PRODUCT CHANGE NOTIFICATION

Select Bourns® Toroid Inductors

Change to Part Number Marking Tape

IC219901

Current Tape

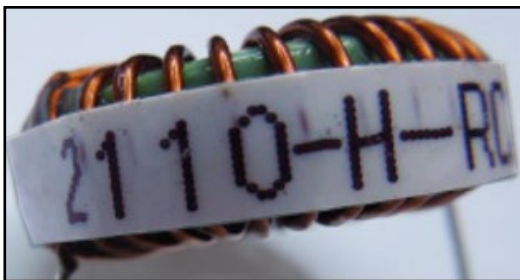
Riverside, California – August 23, 2021 – Effective immediately, Bourns will change the tape used for the component part number marking label from epoxy film electrical tape to glass cloth electrical tape for Model [2100](#), [2200](#), [2300](#), [2100HT](#), [2200HT](#), [2300HT](#), [5700](#), [7100](#), [PM2110](#) and [PM2120](#) Series Toroid Inductors. The abrupt obsolescence of the existing tape by the tape manufacturer requires this change. The replacement tape has similar characteristics to the current tape. A list of affected part numbers is included on the next page.

Replacement Tape

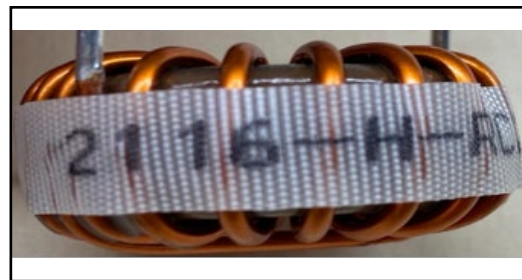
The form of the affected inductors will change due to the change in tape. The fit, function, quality and reliability of the affected inductors remain unchanged. Samples are available upon request.

First date code using the above change: 2133
